BHP Pilbara Strategic Assessment

Jimblebar Optimisation Project Revised Validation Notice

24 August 2023

Scale @ A4: 1:500,000	Prepared: SPATIAL DATA	Project No: A949/81 REV C
Date: 15/05/2023	Checked:	Figure: 4.4
Revision: REV C	Reviewed: ENVIRO. A&I

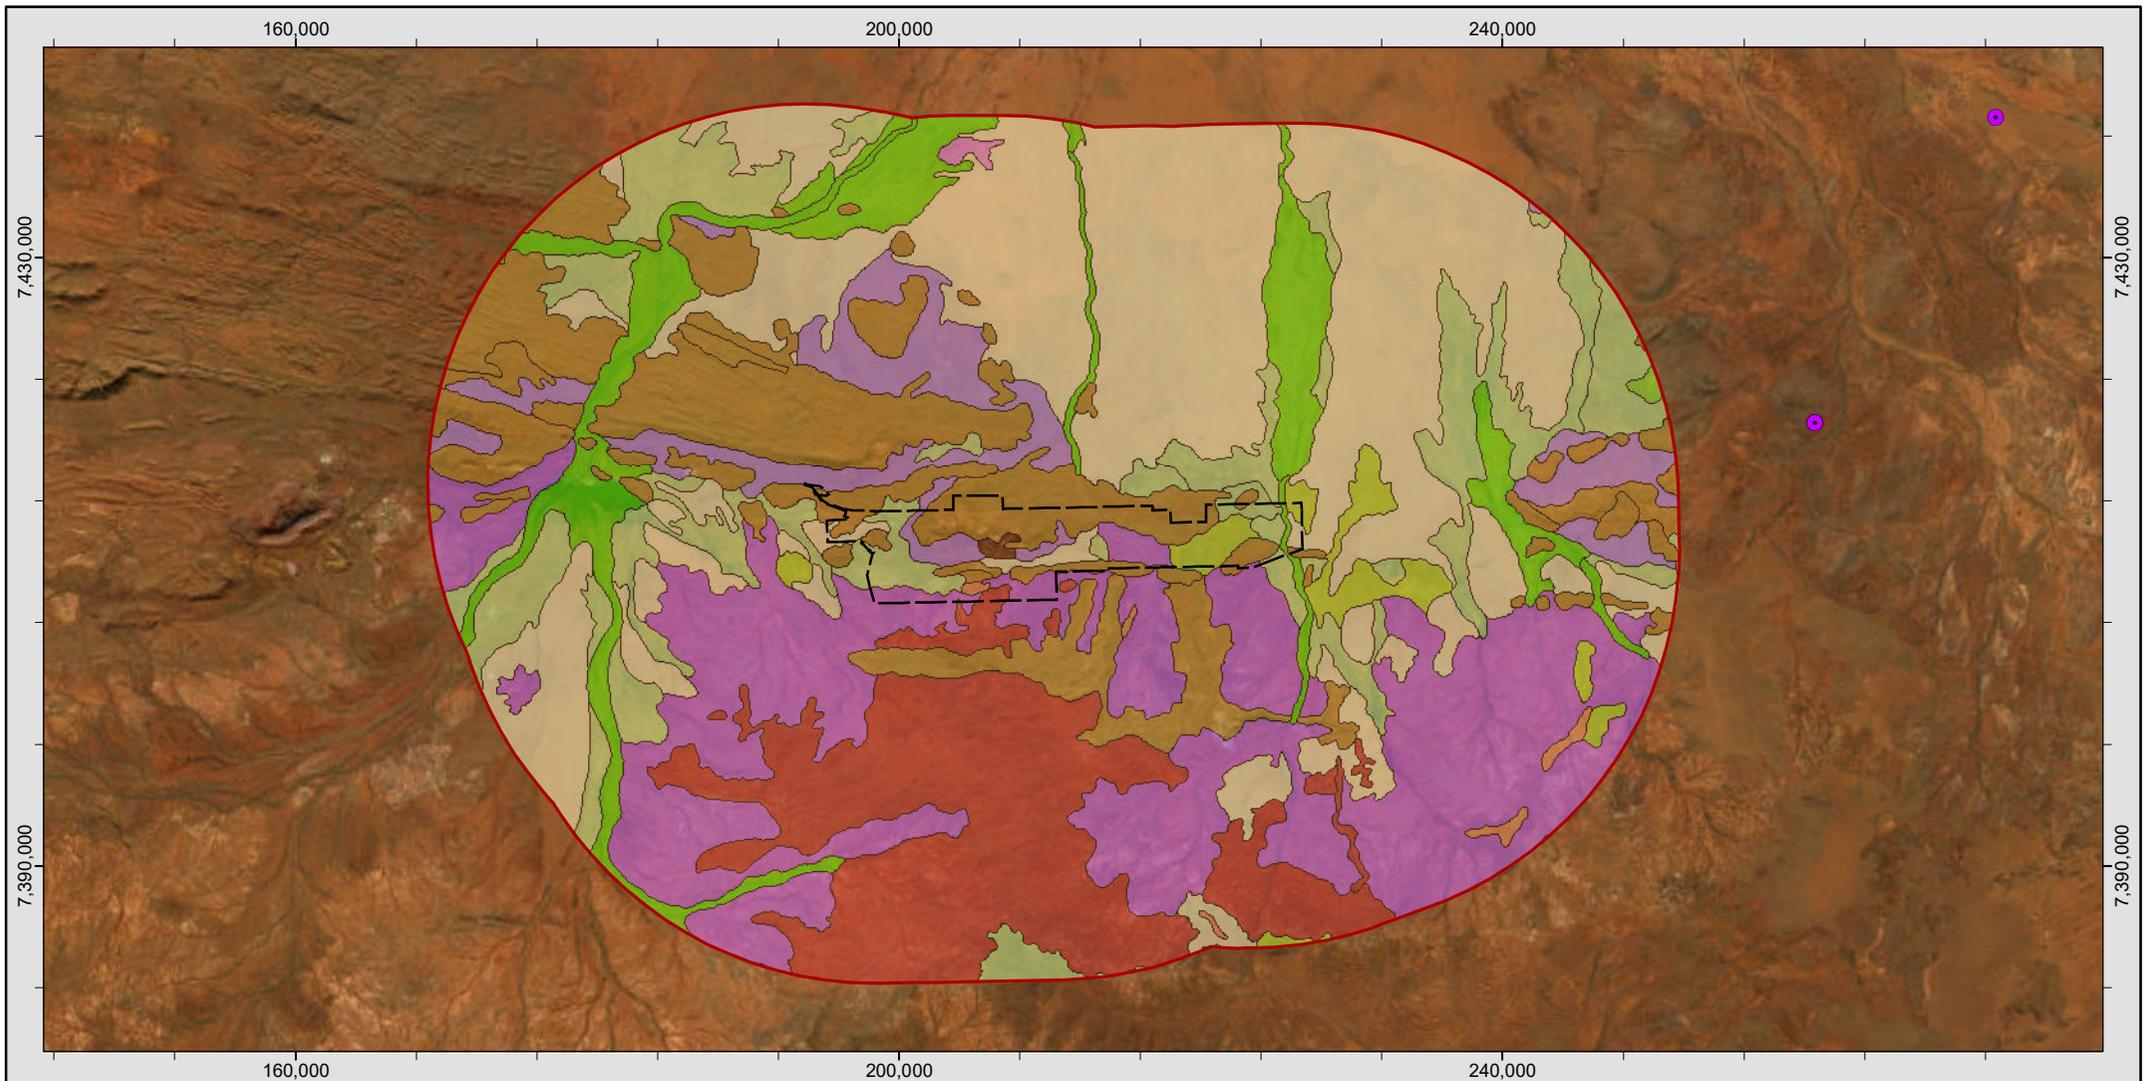
Ghost Bat	<p>4.3.1 Figure 4.4 for Greater bilby in wrong section.</p> <p>4.3.2 Table 4.3: include the units of measurement (ha) in the table header row.</p> <p>4.3.3 Figure 4.5: The extent of the survey coverage area is limited/close to some sections of the Activity Area and indicative footprint, specifically the N/E and S/E</p>	<p>4.3.1 Figure corrected.</p> <p>4.3.2 Amended.</p> <p>4.3.3 Noted.</p> <p>4.3.4 Noted.</p>
